ACTION OF THE ZONING ADMINISTRATOR

On Wednesday, July 15, 1998, the Zoning Administrator approved with conditions a Special Permit Time Extension to construct an office building in the M-2 zone for the project known as Z98-031. Findings of Fact for the project are the same as the previously approved for file P96-003 and are listed in the Resolutions at the end of the original report (see attached). Conditions of approval which include new conditions, a revised condition, and the new expiration date are listed below.

Project Information

SITE PLAN LEVEL 2

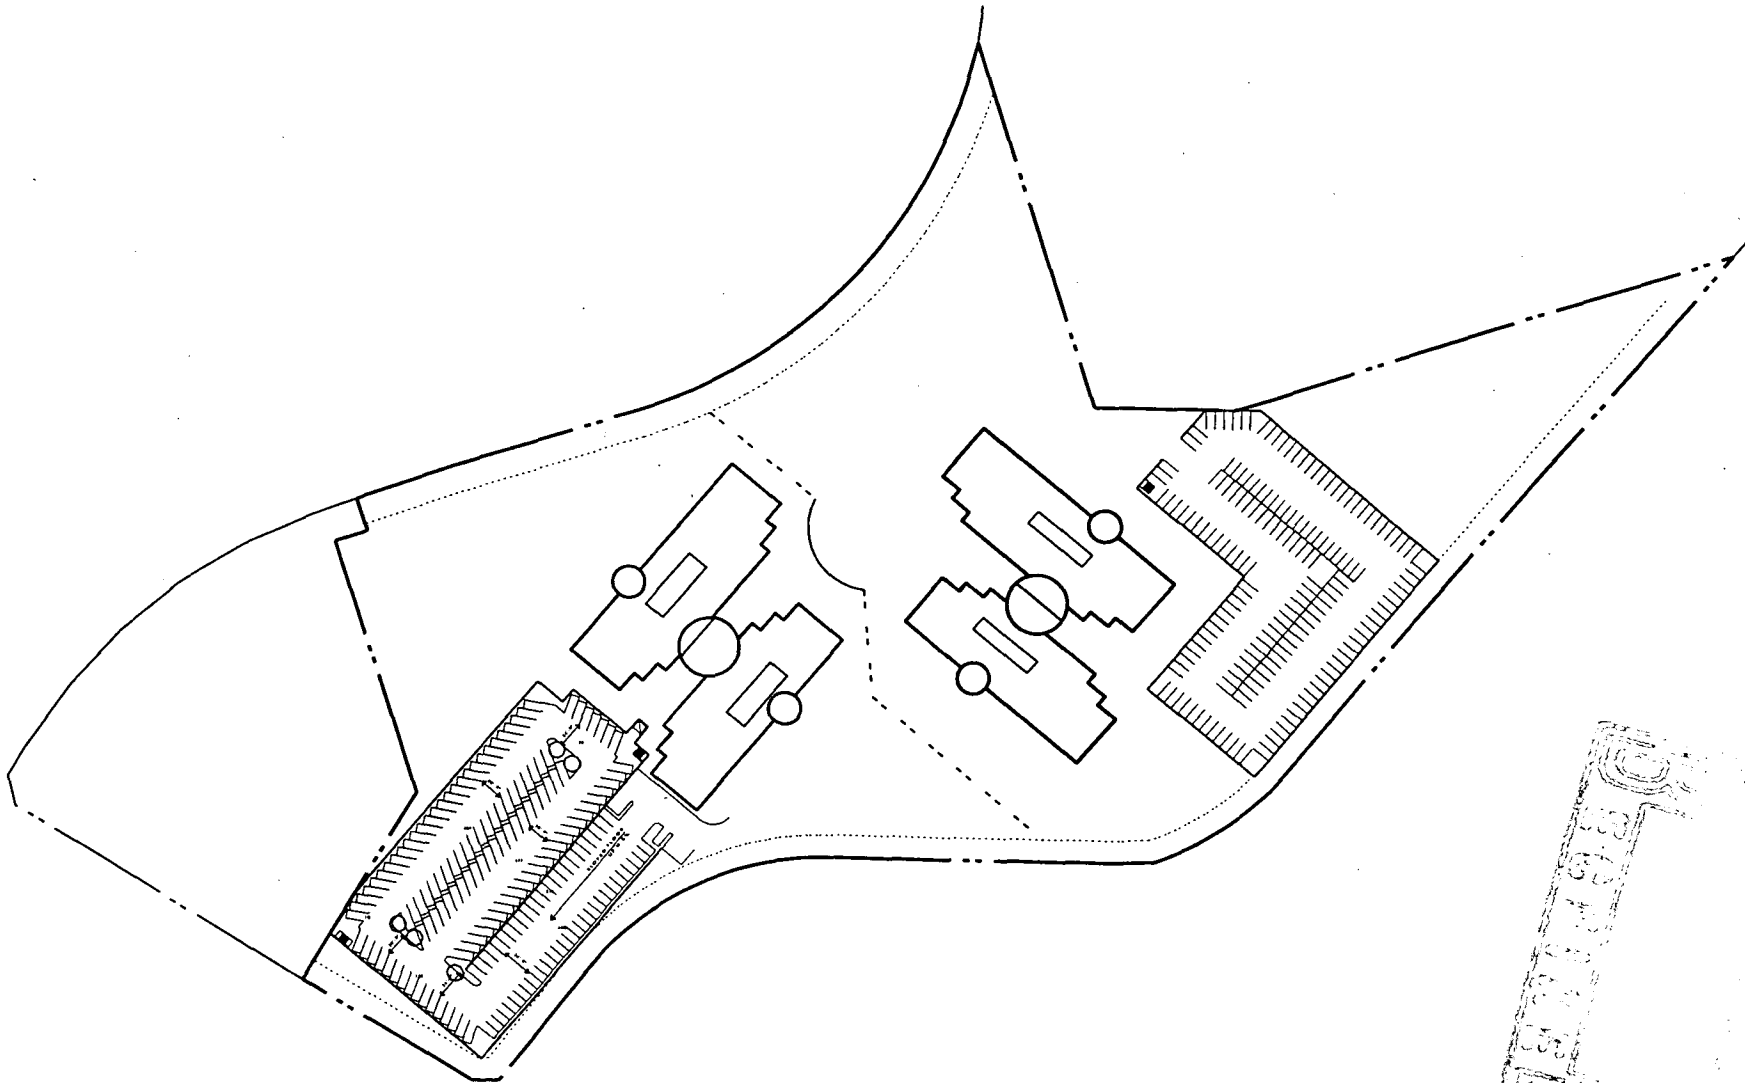
reoriented driveways on the west end. At Public Works request, the applicant has revised the original site plan to comply with driveway conditions. Public Works has reviewed the new site plan and revised a condition and added two new conditions. One additional condition was added to original conditions by the Utility Department.

- g. Capacity or traffic signal improvements at the intersection of Harvard and Silica.
12. The applicant shall provide the following site plan revisions to the satisfaction of the City Transportation Division:

- a. Complete site plan of ground level parking, unobstructed by parking decks;
 - b. Show both sides of Harvard Street with all existing and proposed driveways on both sides;

- c. Show existing access easements to adjacent hotel; and
 - d. The applicant shall redesign driveways to the satisfaction of the Traffic Engineer.
13. ~~The applicant shall provide a design for the westernmost driveway entrance that will be in alignment with a corresponding driveway to be provided on the USAA site to the west (DELETED) NEW:~~ Modifications to the existing driveway at the northwest corner of Building Two shall be subject to detailed review and approval by the
